**MCPB** Item No.: 2 Date: 7-24-17

Willow Manor at Fairland: Preliminary Plan No. 120170080, Site Plan No. 820170050, and Mandatory Referral No. MR2017003

**SITE PLAN NO. 820170050:** Staff recommends approval of the Site Plan with all site development elements shown on the latest electronic version as of the date of this Staff Report dated July 12, 2017, submitted via ePlans to the M-NCPPC except as modified by the following conditions.<sup>[1]</sup>

Figure 6 - Parking Distribution

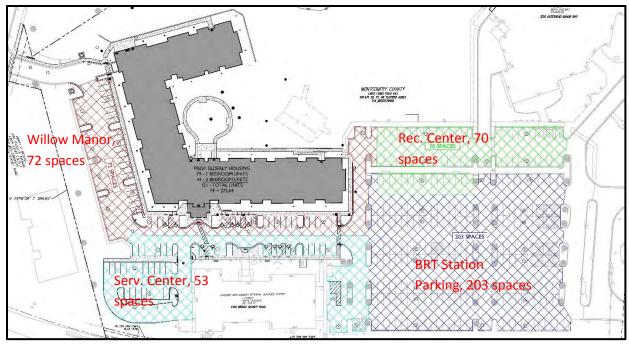
Overall, the entire Subject Property requires a minimum of 352 parking spaces to meet all the requirements of Division 6.2 for all uses, proposed and existing, on the Subject Property. The Applications will ultimately provide 398 parking spaces to be split amongst all the uses.

- a) All on-site sidewalks must be a minimum of 5 feet wide.
- b) The Applicant must correct the total "Provided" parking calculations in the "Vehicular Parking Tabulation" table.

- c) The Applicant must revise Sheet 32-APE-820170050 by modifying the color-coded areas to reflect correct number of parking spaces labeled on the drawing.

Figure 7 – Bike Locker Location

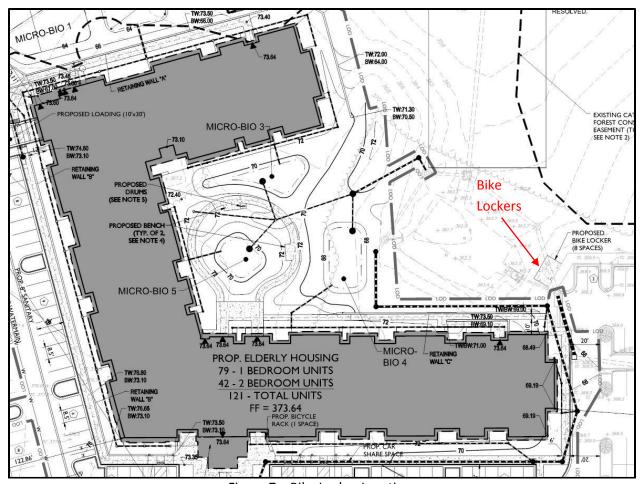
However, Section 6.2.10 allows the Planning Board to grant a waiver to reduce the number of bicycle parking spaces. The Applicant is requesting to reduce the number of bicycle parking spaces from 31 to 9, eight of which would be spaces for long-term use and one would be for short-term use (Figure 7).

Staff recommends that the Planning Board grant the waiver to reduce the number of bicycle parking spaces because the nature of the use does not create high demand for bicycle facilities. They are not likely to travel by bicycle. The eight bicycle parking spaces for long-term use that staff recommends are expected to be used by employees of the Independent Living Facility for Senior or Persons with Disabilities and the active residents. Approval of this waiver meets the intent of the bicycle parking requirements because sufficient bicycle parking will be provided for the proposed use.

- j) Add detailed specifications of the bike lockers in the location shown on the Certified Site Plan.
- k) The Applicant must submit and receive approval of a revised Stormwater Management Concept to address comments from the Montgomery County Department of General Service prior to the submittal of the Certified Site Plan.

Figure 11 - Protected Trees to be retained but impacted (green dot)

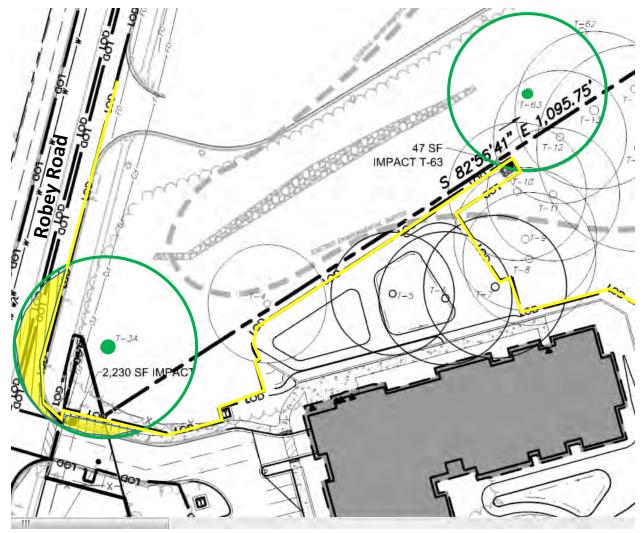
<u>Variance Request</u> – The Applicant submitted a variance request in a letter dated May 8, 2017, for the impacts/removal of trees (Attachment 14). The Applicant proposes to impact, but not remove two (2) Protected Trees that are 30 inches or greater, DBH, and considered a high priority for retention under Section 22A-12(b)(3) of the County Forest Conservation Law. These trees are noted as T-3A and T-63 on the FCP, listed in Table 3, and shown graphically in Figure 11. Tree T-3A is located on-site within existing forest, near the existing driveway entrance from Robey Road, and its critical root zone will be impacted for the construction of the water and sewer line connections to serve the proposed residential building. T-63 is located off-site, within existing forest, on the adjacent Greencastle Elementary School property, and its critical root zone will be impacted for the construction of a storm drain outfall.
